D350-748-143TRN
Job Sheet 191008

Part Name: Ss Crosstube Turning Detail

DART AEROSPACE LTD	Work Order: 191008
Description: Crosstube Assembly (AS350/355 High Fwd SS)	Part Number: D350-748-143
Inspection Dwg: D350-748-143 Rev: A	Page 1 of 2

DRAWING NO. D350-748-143	TITLE CROSSTUBE	REV. A	DART AEROSPACE LTD ENGINEERING ORDER		D.E.O. NO. D350-748-143-A-1	SHEET NO. SHEET 1 OF 1	SCALE NTS
DRAWN 92	CHECKED ASS		MFG. APPR. <i>[Signature]</i>	APPROVED <i>[Signature]</i>		DE APPR. <i>[Signature]</i>	
DATE 15.11.18	DATE 15.11.18		DATE 16.02.19	DATE FEB 19 2016		DATE 2016.02.19

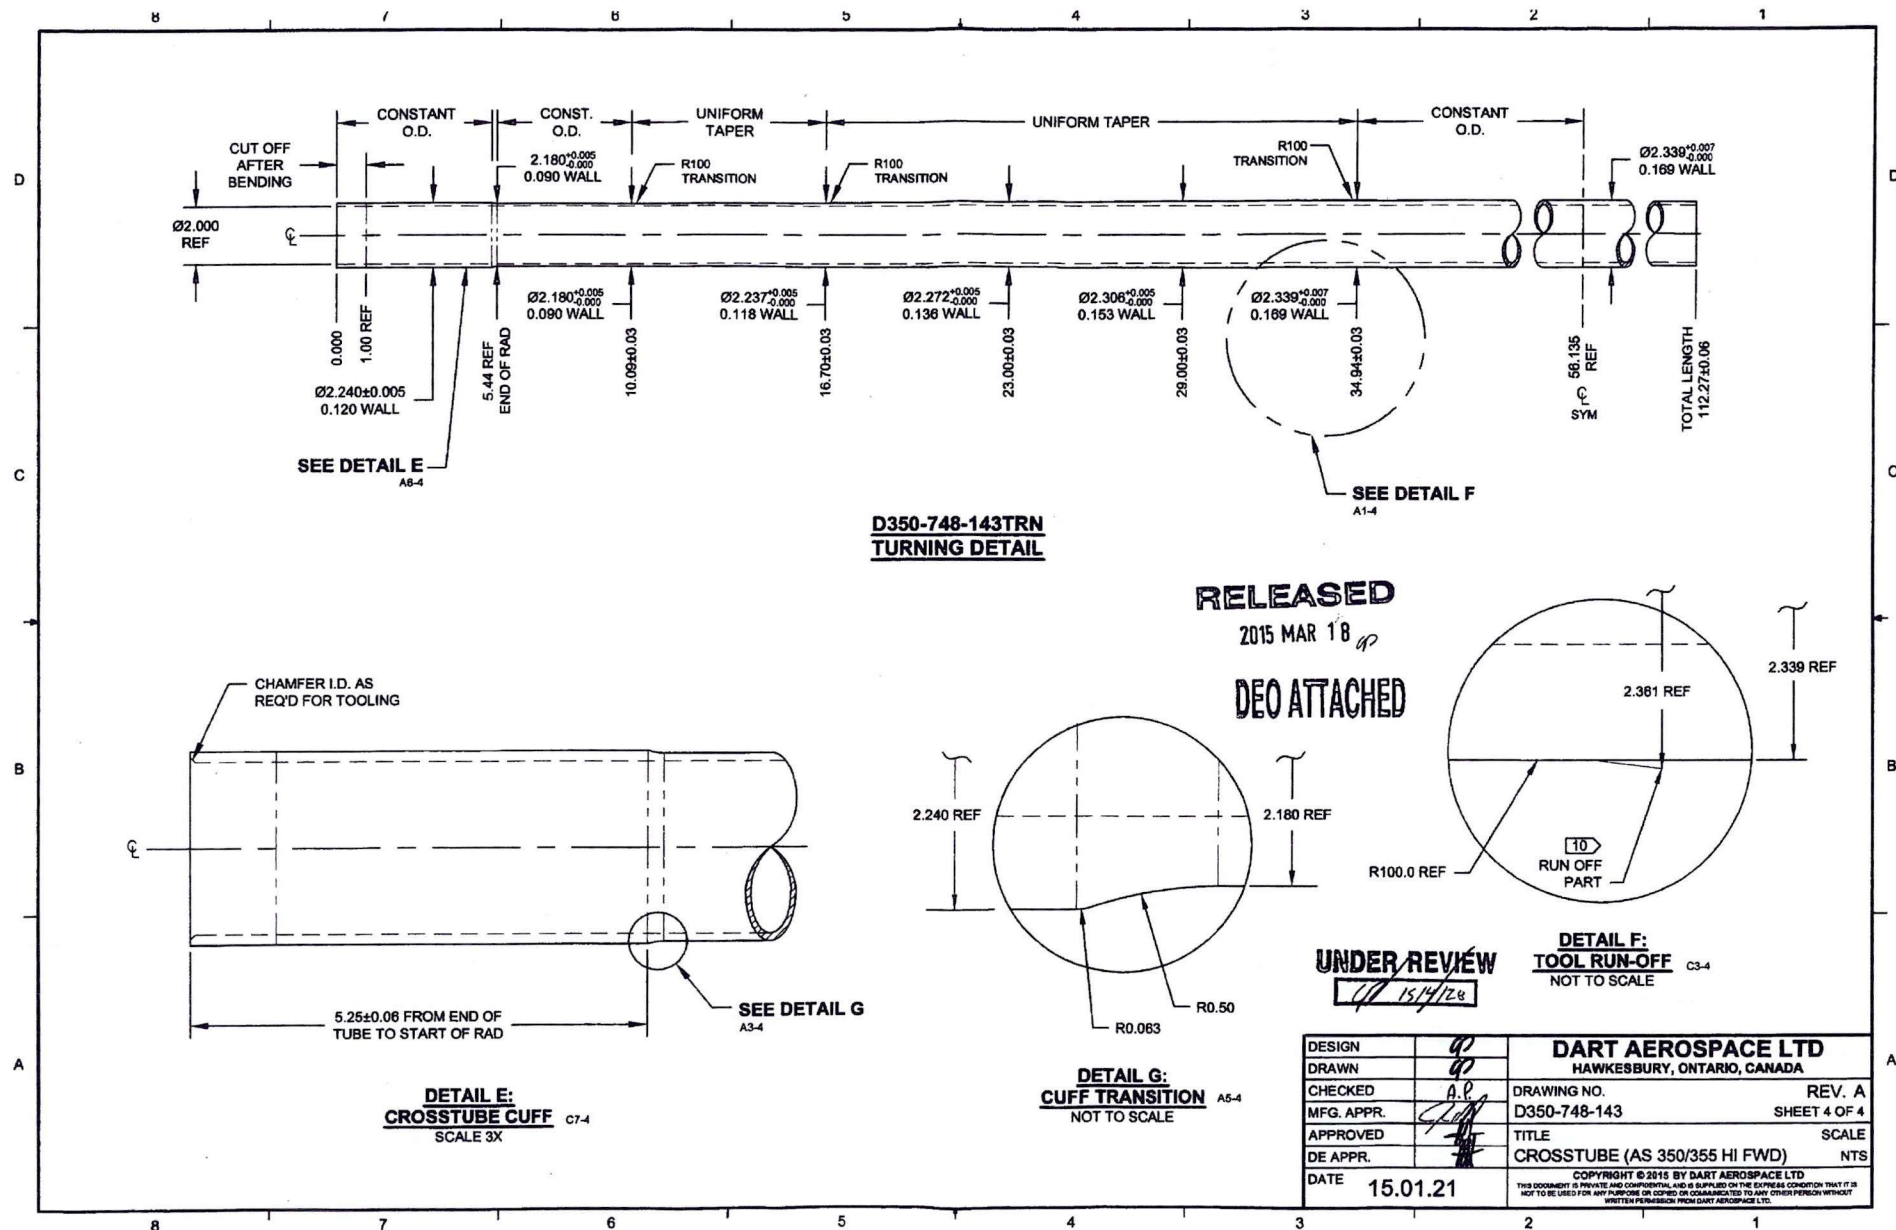
AMEND NOTE 2 (SHEET 1) AS FOLLOWS:

2) FINISH: PREPARE SURFACE PER DART QSI 005 4.1.4
PRIME INSIDE AND OUTSIDE PER DART QSI 005 4.2
PAINT OUTSIDE PER DART QSI 005 4.2

OR

POWDER COAT WHITE (4.3.5.2) PER DART QSI 005 4.3
